**DRAFT**  
**MASTER DEVELOPMENT DRAINAGE REPORT**  
**FOR**  
**MEADOWLAKE RANCH**  
**(SKETCH PLAN)**

**SKP-18-004**

**AUGUST 2018**

Prepared by:  
**TERRA NOVA ENGINEERING, INC**  
**721 S. 23<sup>RD</sup> STREET**  
COLORADO SPRINGS, CO 80904  
(719) 635-6422

PROPOSED DRAINAGE PLAN

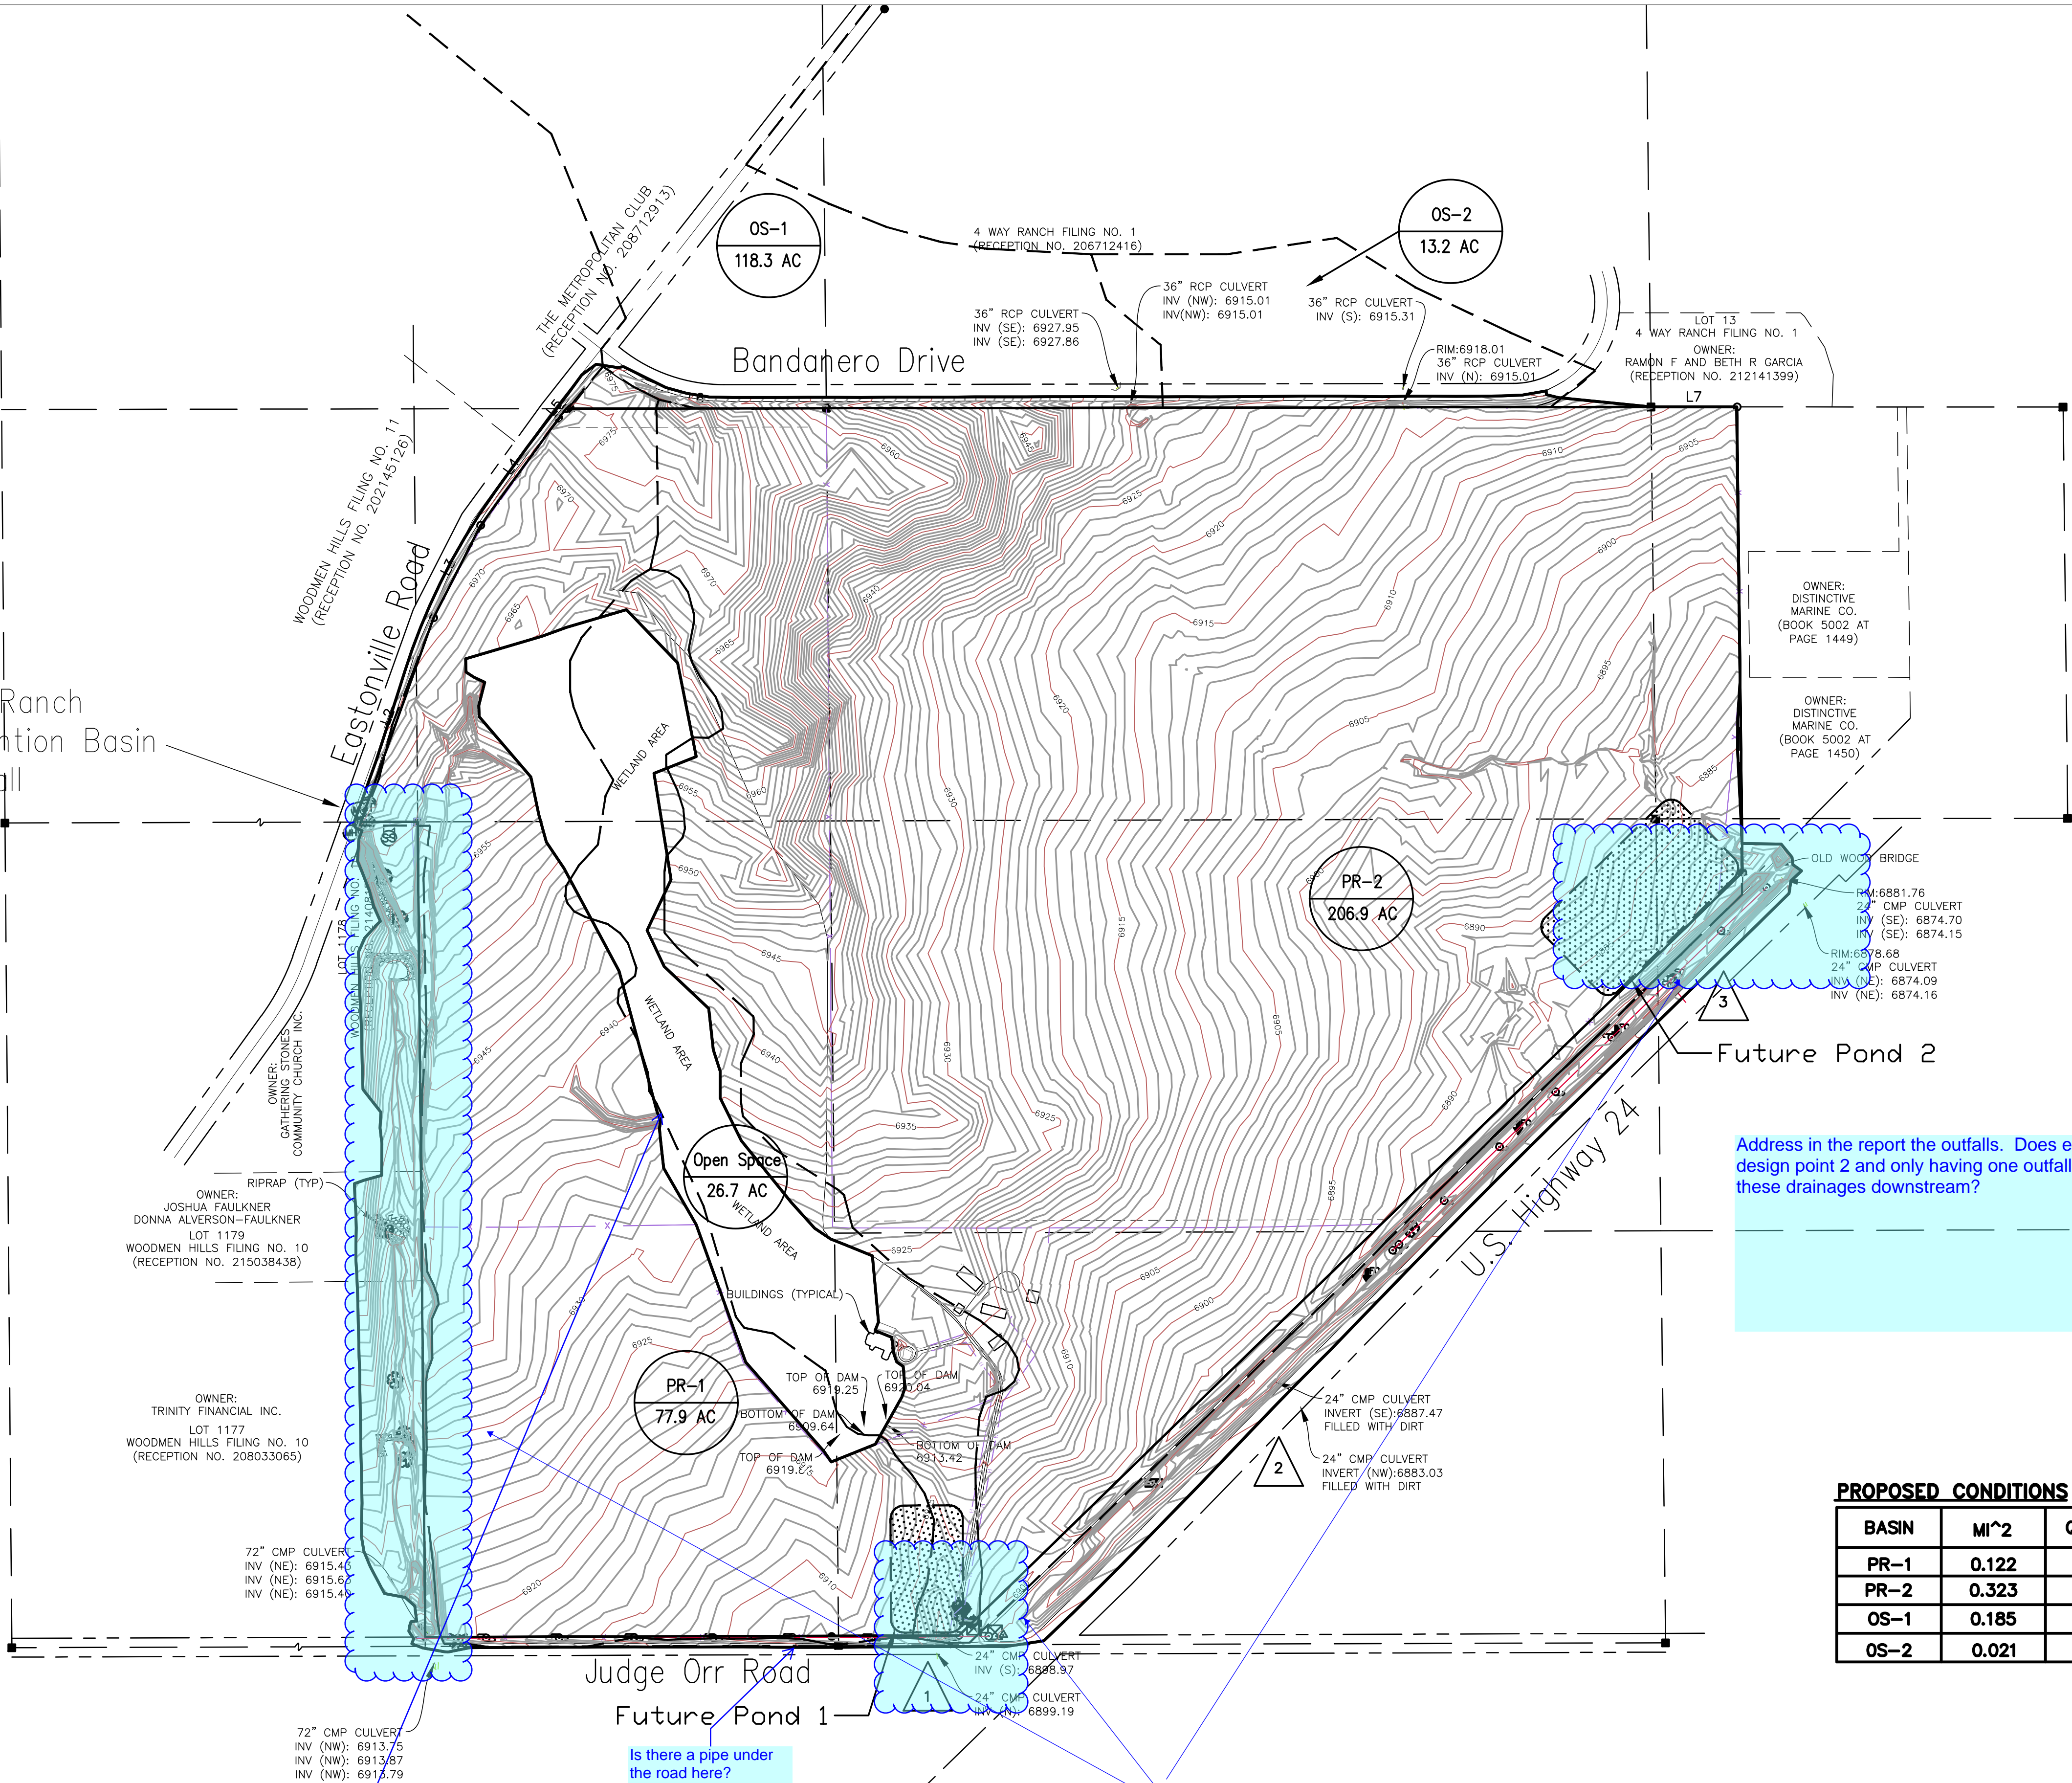
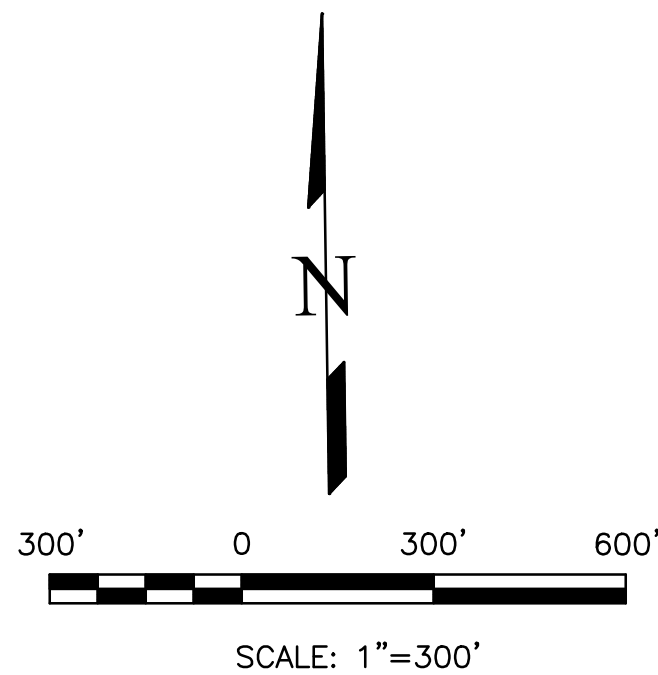
Provide a clear property line  
linetype

Address in the report the outfalls. Does eliminating the outfall at  
design point 2 and only having one outfall (design point 3) impact  
these drainages downstream?

If this Wetland area does  
not need to be accounted  
for in the final drainage  
calculations then provide  
an exhibit that shows how  
this volume is contained.

Is there a pipe under  
the road here?

Provide exhibits that demonstrate how the 100 year storm can be routed to these areas, how the roadside ditches  
can be captured and routed to these areas, and show the existing culverts. The current scale of these drawings is  
such that you cannot see the contours and elevations.
